Access Compliance Report

Public Rights-of-Way

| Intersection ID: 2684 | Main Street: CARDINAL_POINT_RD | Cross Street: SUMMERGOLD_WY | Location: SW |
| ADA ID: A0B6E9387AEC | Ramp Type: Perp | Initial Pass/Fail: Fail | Overall Compliance: No |

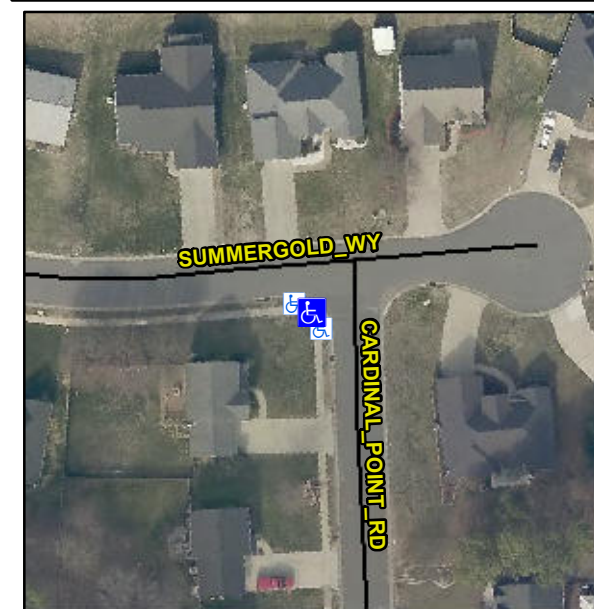
Not Found, R304.2.2

| Compliance | Description | Data | Compliance | Description | Data |
|------------|-----------------------|-------|------------|-----------------------------|------|
| N/A | Ramp Length (in) | 49.0 | No | Ramp Slope (%) | 9.1 |

Remove & Replace Entire Ramp.
